SUPPLEMENT 8
CONVERSION PACKAGE SECTION 3.1
PAGE INSERTION INSTRUCTIONS

Remove and insert the following pages into Enclosure 2 to Serial: RNP-RA/96-0141.

9709150203 970910
PDR ADOCK 05000261
P PDR

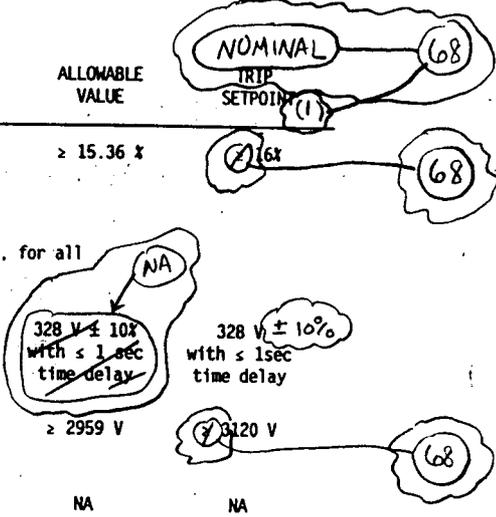
[M1] (1) A channel is OPERABLE with an actual Trip Setpoint value found outside its calibration tolerance band provided the Trip Setpoint value is conservative with respect to its associated Allowable Value and the channel is re-adjusted to within the established calibration tolerance band of the Nominal Trip Setpoint.
